Proof of Evidence - Design

**Land north of Cambridge
North Station, Cambridge**

PINS Reference: APP/W0530/W/23/331561

Annemarie de Boom MSc on behalf of
South Cambridgeshire District Council

Figure 23 S9 cycle store access

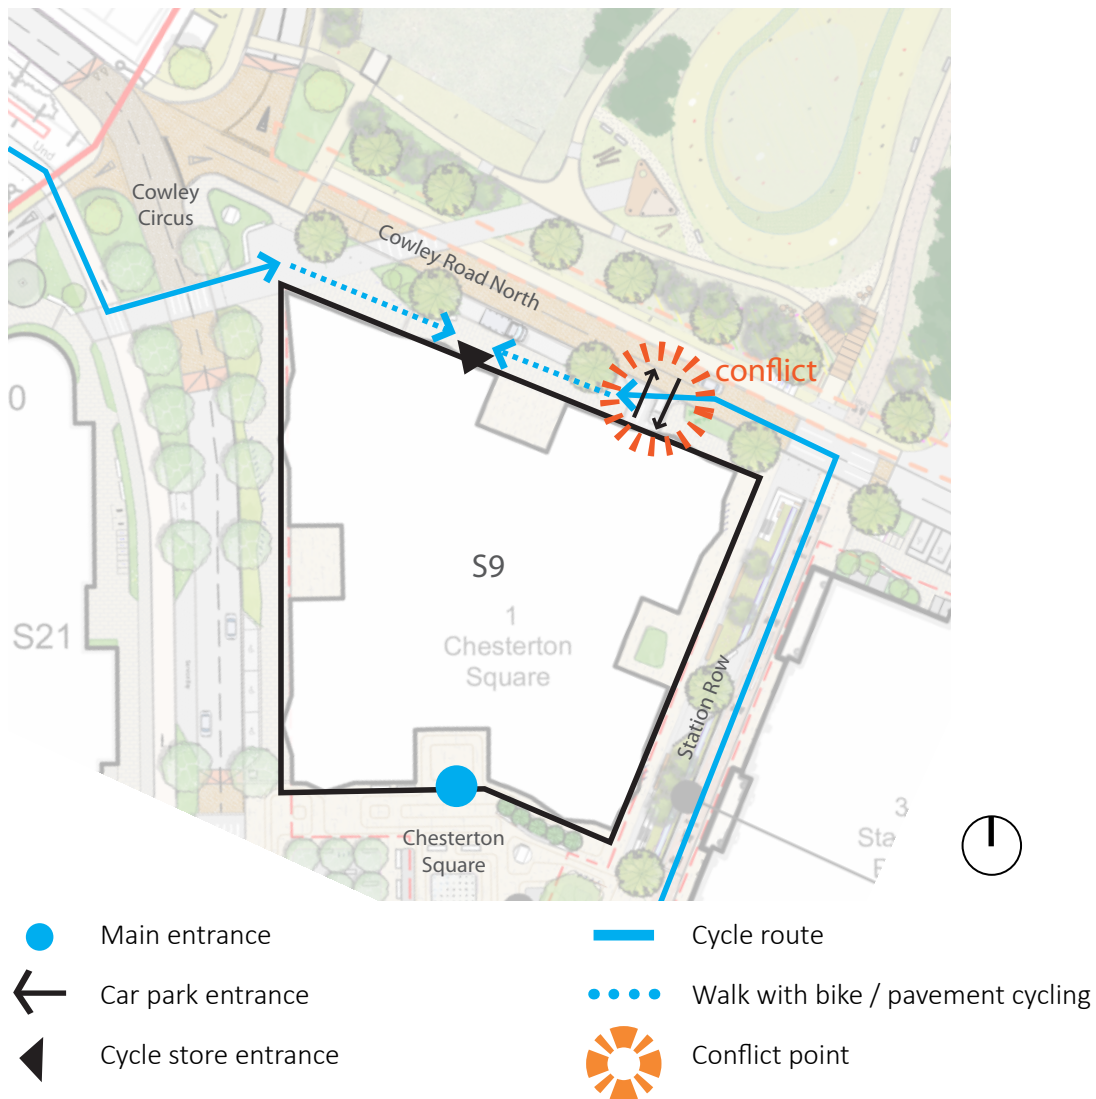
- 5.73 The building entry point for cyclists to S9 is located on the northern side of the building. This is the location furthest away from the main entrance and – as it also provides access to the plant, refuse store and basement car park – considered as the “back” of the building.

- 5.75 Furthermore, the store is not directly accessible from the cycle paths on Milton Avenue (which is located on the other side of the road) or Station Row. When arriving from Station Row, which provides the most direct route to the station and the city centre, cyclists cross the path of vehicles entering and existing the basement car park, creating an area of potential conflict as illustrated in Figure 23 Page 39. This compromises the convenience and attractiveness of using the bike store.

- 5.76 The detailed design for the public realm proposes a service bay immediately outside the entrance to the cycle store, blocking direct and convenient access to Cowley Road north. This is likely to result in cyclist using the pavement causing conflicts with pedestrians.

Figure 24 Cycle store access to residential quarter

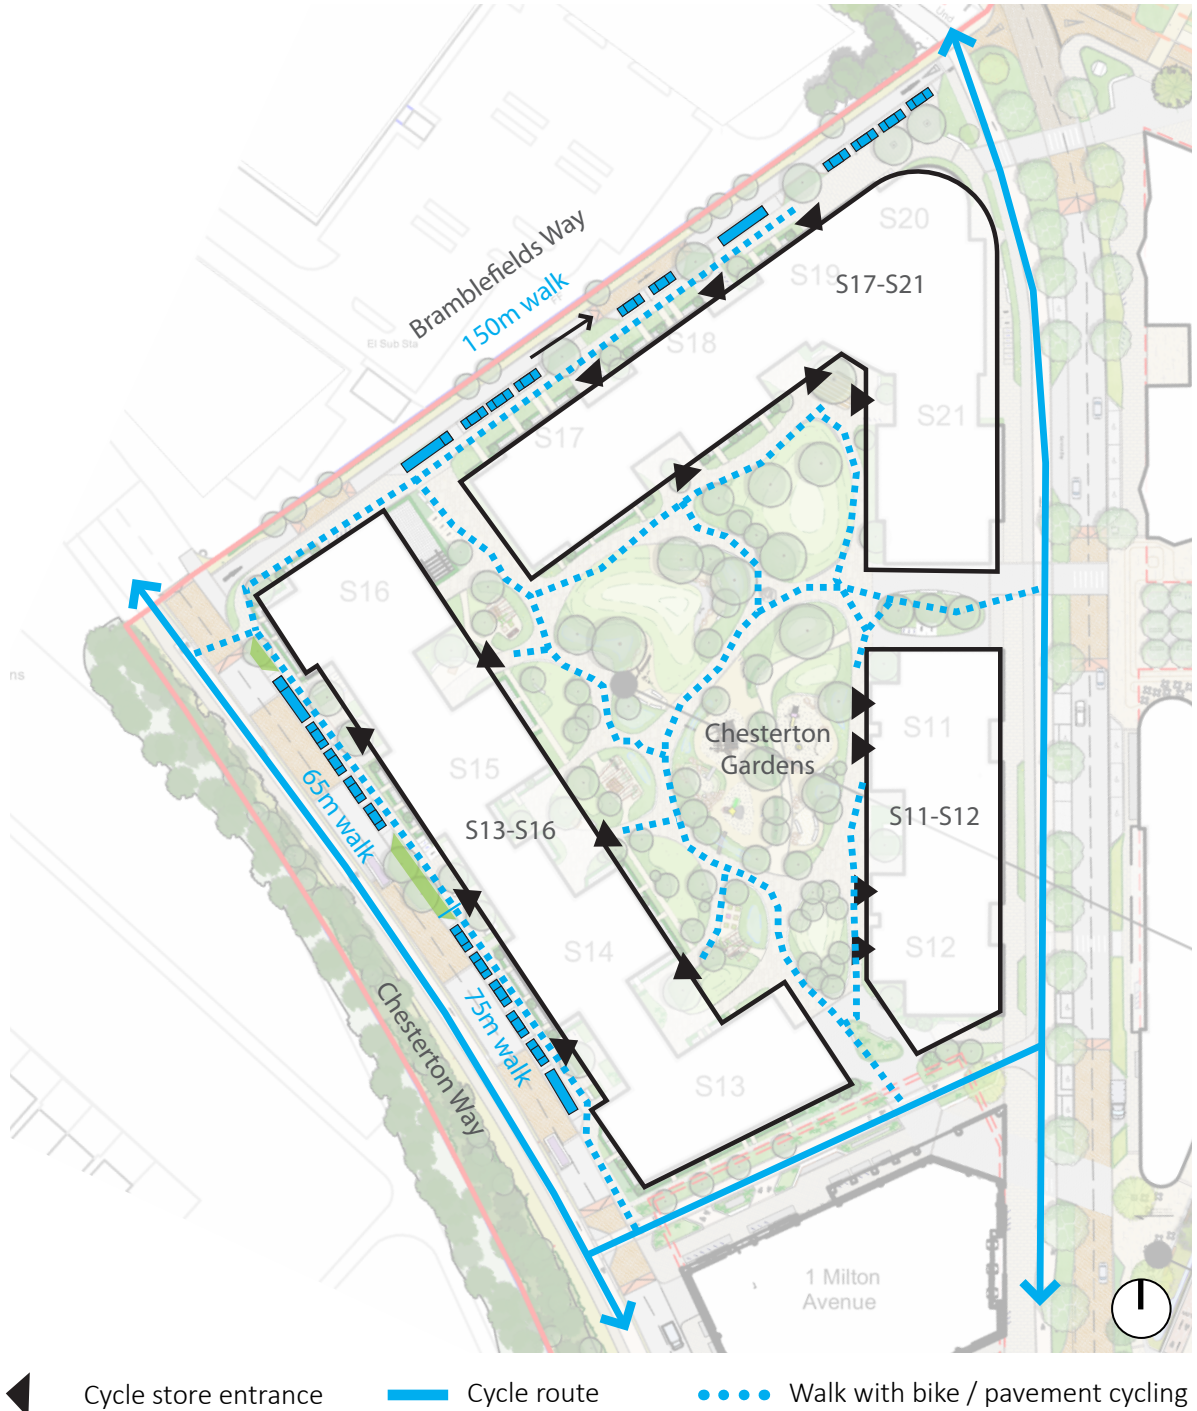
- 5.77 The proposed entrances to the cycles stores of Blocks S11 to S21 are not well coordinated with the design of the public realm, as illustrated in Figure 24 Page 40.

- 5.79 There are three entrances proposed to cycle stores in Building S13-S16 from Chesterton Way. But the public realm design for this street proposes near continuous on-street parking in front of the building. There is just a single break in the row of parking, but this is proposed as a planted verge. To access the cycle path, which is located on the far side of Chesterton Way, cyclists would be required to walk around the line of parked cars – a distance of up to 70m. This is not convenient and likely to result in cycling on the pavement.

5.80 There are also three entrances proposed to cycle stores in Building S17-S21 from Bramblefields Way. Bramblefields Way is a one-way street (northbound) and the detailed design for the public realm does not propose a contraflow cycle lane. Furthermore, the tight alignment of the street and building as fixed in the parameter plans would not allow for one to be introduced. Any cyclist seeking to join the strategic cycle route along Chesterton Way would be required to walk 150m along the footway. This is unlikely to be acceptable to most cyclists and would result in cycling on the pavement or on the carriageway against the flow of traffic. This would potentially endanger cyclists and / or pedestrians.

Figure 25 Impact of a stepped building frontage on overshadowing and overlooking

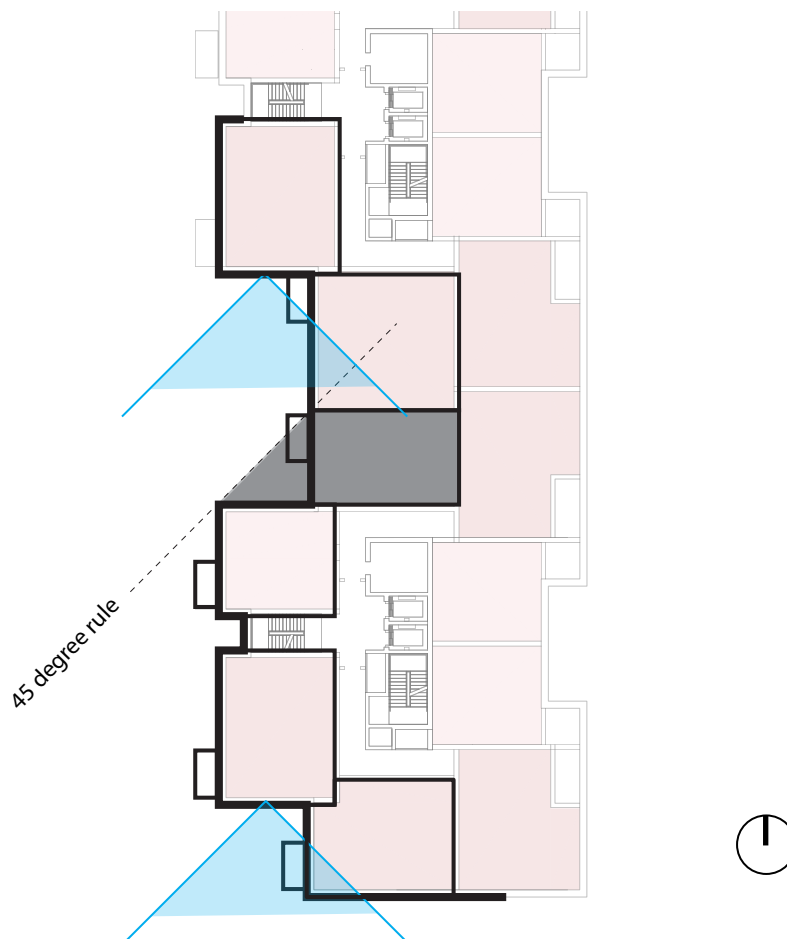
- 5.92 I agree with the above interpretation as an opening window onto a short section of external wall does not deliver the benefits of a dual aspect over single aspect dwelling set out in paragraph 5.87.
- 5.93 Furthermore, there may be issues approving a stepped frontage at Reserved Matters stage as a stepped frontage has some inherent issues. This includes the impact of the projecting volume on sun and daylight access to the adjoining ‘stepped back’ unit (especially on a north-south orientated blocks). For example, the proposals for S11-12 would not meet the 45 degree rule set out in the District Design Guide as indicated on Figure 25 Page 42. Also, the introduction of a sizeable window on a second external wall created by a stepped frontage could give rise to overlooking issues as also illustrated in this Figure.

Figure 26 S11 and S12 single aspect dwellings

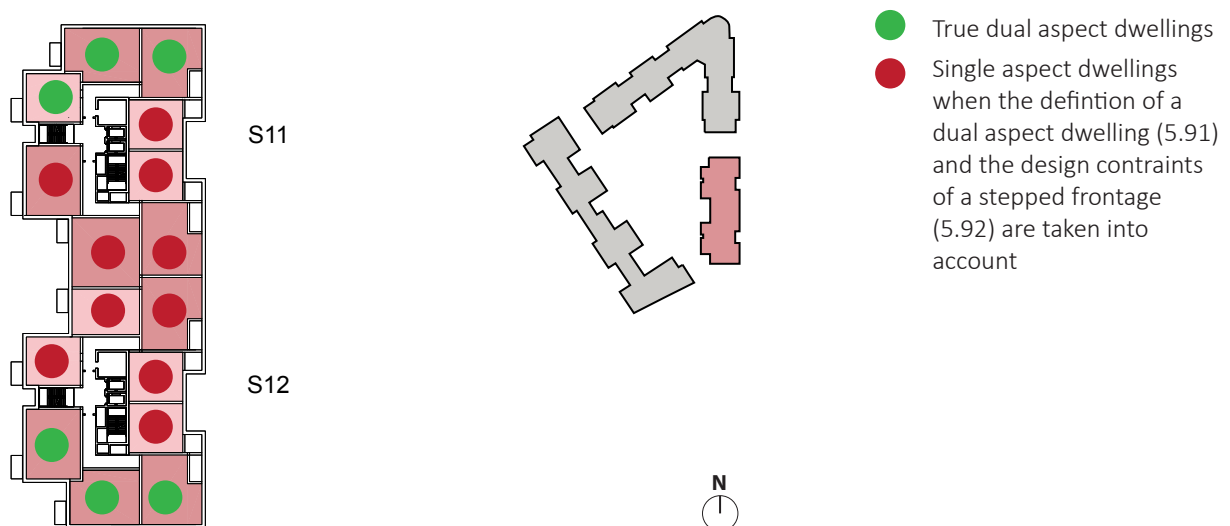
- 5.94 Figures 26 to 28 on Pages 43 and 44 illustrate the number of dual aspect dwellings on a typical floor plan of the proposed residential blocks in proportion to the number of dwellings that are single aspect when considering the definition of a dual aspect dwelling and take account of the design constraints on a stepped frontage as described above.

- 5.95 This demonstrates that the proportion of single aspects homes on a typical floor level of the illustrative design is over 50%. There is little confidence that this figure can be much improved upon considering the constraints imposed on the design and siting of the blocks by the detailed parameter plans.
